Product Advisory (PA)

Subject: Changes to the Power-up / Power-down Sequencing and Recovery from Brown-out Condition

This notice is to inform you that the High-Performance Serial MRAM Memory datasheet has been updated as follows:

Figure 1: Power-Up Behavior

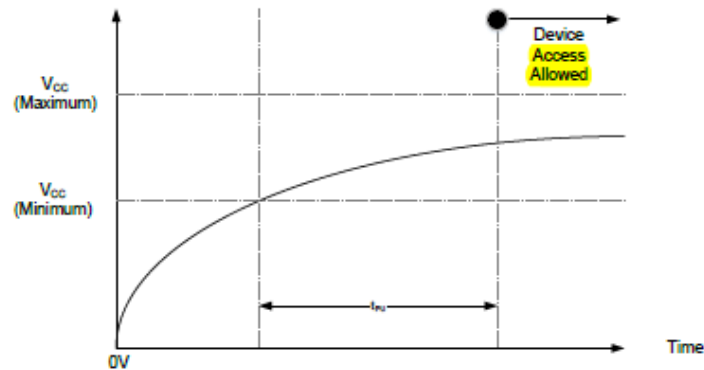
- Ramp up V_{CC} (t_{RVR})
- CS# must follow V_{CC} during power-up (a 10K Ω pull-up Resistor to V_{CC} is recommended)
- It is recommended that no instructions are sent to the device when V_{CC} is below V_{CC} (minimum)
- During initial Power-up, recovering from power loss or brownout, a delay of t_{PU} is required before normal operation commences
- Upon Power-up, the device is in Standby mode

Figure 7: Power-Down and Brown-out Behavior

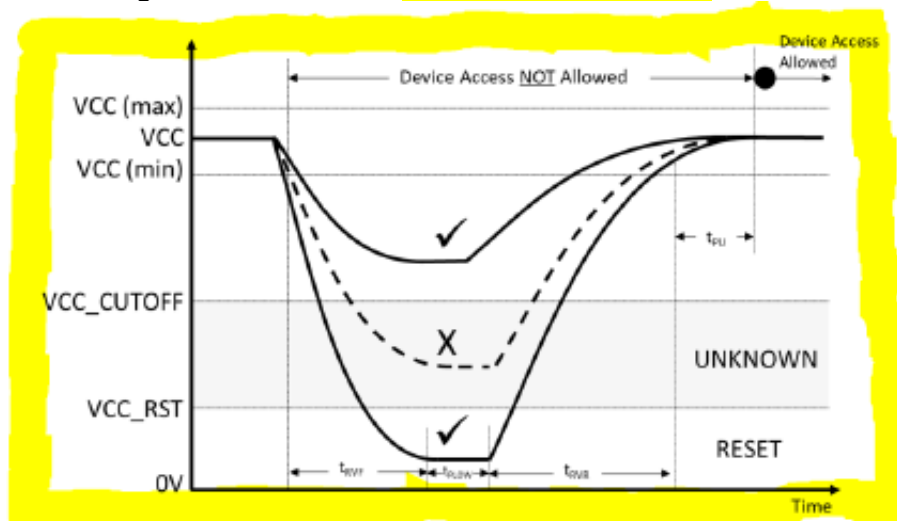
- Ramp down V_{CC} below V_{CC_RST} level
- CS# must follow V_{CC} during power-down (a 10K Ω pull-up Resistor to V_{CC} is recommended)
- The device must not be selected and that no instructions are sent to the device when V_{CC} is below V_{CC} (minimum)
- The Power-up timing and device initialization needs to be observed after V_{CC} ramps up above V_{CC} (minimum)
- To stabilize the V_{CC} level, suitable decoupling capacitors close to package V_{CC} pin is recommended
- Chip functionality not guaranteed if V_{CC} ramps down between V_{CC_CUTOFF} and V_{CC_RST} and then ramps up to V_{CC}
